Design Change of Display Mounting Systems

Display Mounting Systems - Single Axis Type and Tablet PC Holders - Single Axis Type - Clamp Lever Retention - Magnet Mounting will be changed as follows. Prices will not change as a result of this specification change.

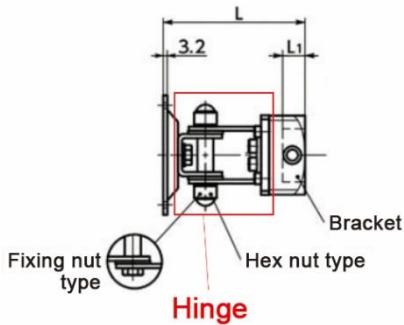
The common hinge in the pertinent products will be changed to the specifications below (image is DFSN-AA).

Changes	Before Change	After Change

The dimensions and performance on the product pages will remain the same.
